OFFICE OF INSPECTION AND ENFORCEMENT  
DIVISION OF INSPECTION PROGRAMS

Report Nos.: 50-269/86-16; 50-270/86-16; and 50-287/86-16

Facility Name: Oconee Nuclear Station

Inspection Conducted: May 5 - June 11, 1986

STEAM SUPPLY FOR TURBINE DRIVEN EFW PUMP (UNIT 1.)

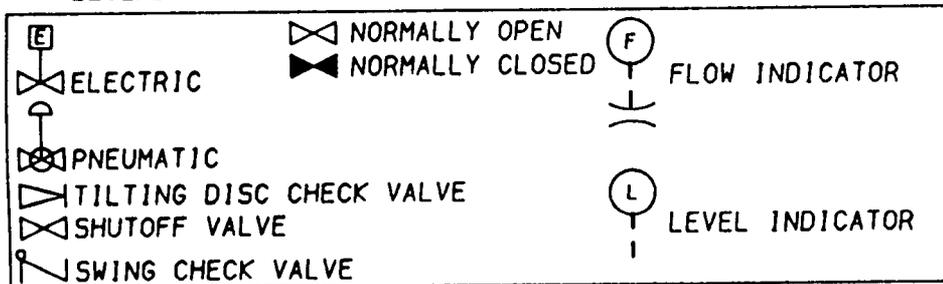
EFW turbine steam supply relief valve MS-92 did not have sufficient capacity to prevent piping between valves MS-87 and MS-93 from exceeding piping design pressure assuming that MS-87 failed open as designed. Figure 1 on page 17 shows the layout of this piping. Independent analysis by the team concluded that piping between MS-87 and MS-93 could be pressurized to approximately 450 psia. This analysis assumed 1065 psia in the SGs, MS-93 shut, and MS-92 open and discharging at a capacity consistent with the overpressure condition. During the inspection, the licensee acknowledged that MS-87 was not physically restrained from failing fully open. Analysis by the inspection team concluded that MS-87 would have to be restrained from opening beyond approximately 80% to eliminate this condition. Review of maintenance history indicated that MS-87 had failed open in the past. However, the effects of overpressurization were not addressed because the relief valve was thought to be adequately sized by the licensee's operations and maintenance personnel.

FIGURE 2.  
SIMPLIFIED EMERGENCY FEEDWATER SYSTEM ARRANGEMENT FOR UNIT 1.

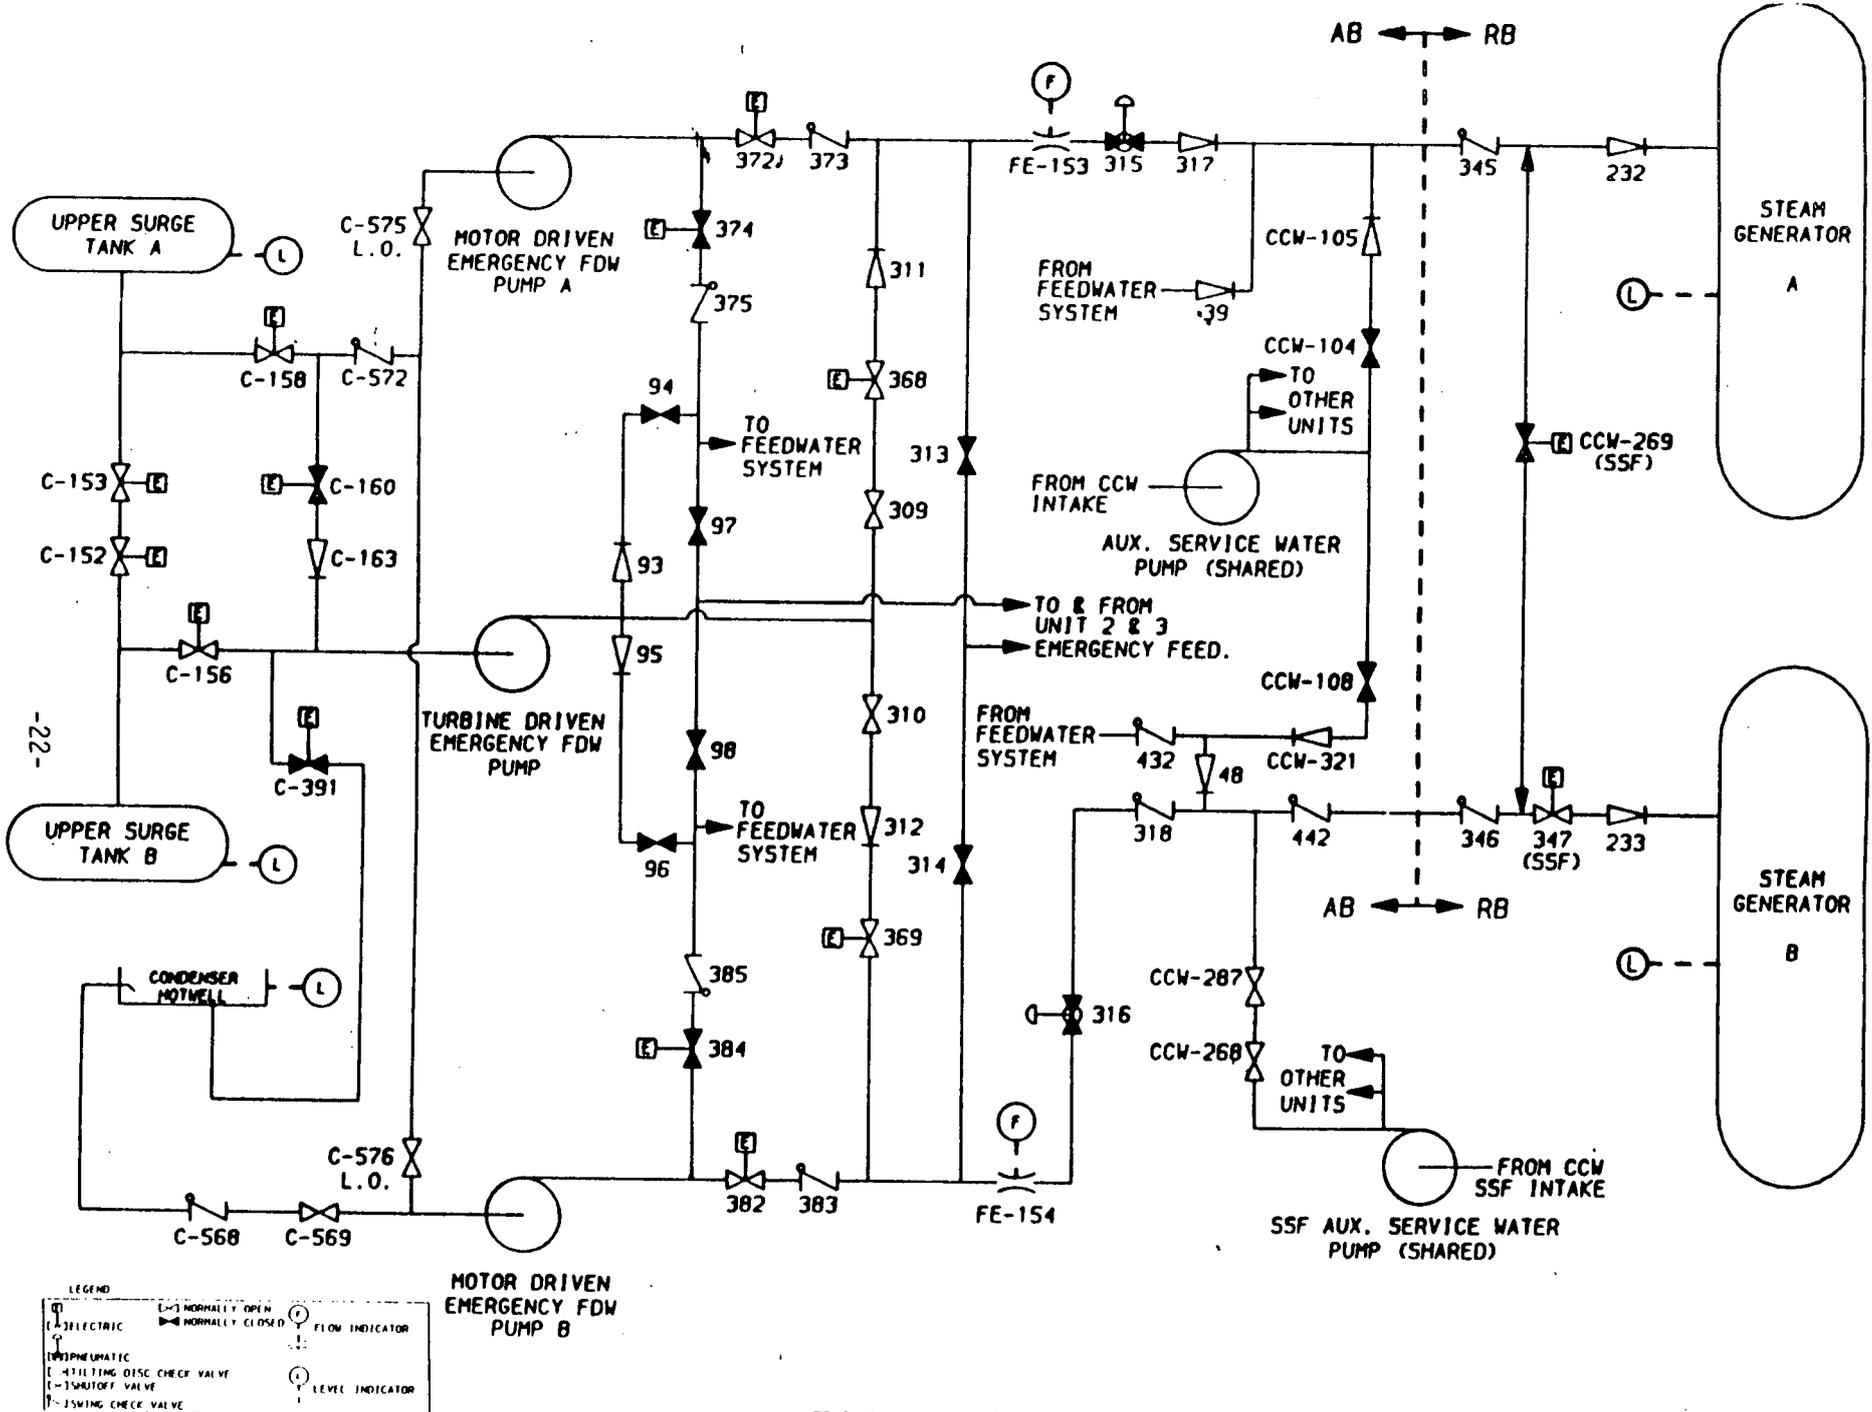
Figure 2 on page 22 illustrates the EFW piping configuration for Oconee Unit 1 at the time of the inspection. The EFW piping configuration for Units 2 and 3 were similar to Unit 1 in most significant details.

The FSAR stated that the EFW system was capable of withstanding the maximum hypothetical earthquake (equivalent to a safe shutdown earthquake) and that the failure in the nonseismic portion of attached piping would not cause the loss of function to the EFW system because automatic and remote manually operated seismic/non-seismic boundary valves are used. Contrary to this commitment in the FSAR, substantial portions of the EFW system were not designed to be capable

of withstanding the maximum hypothetical earthquake. This deviation was recognized by the licensee before this NRC inspection as documented by LER 86-002, dated March 5, 1986.
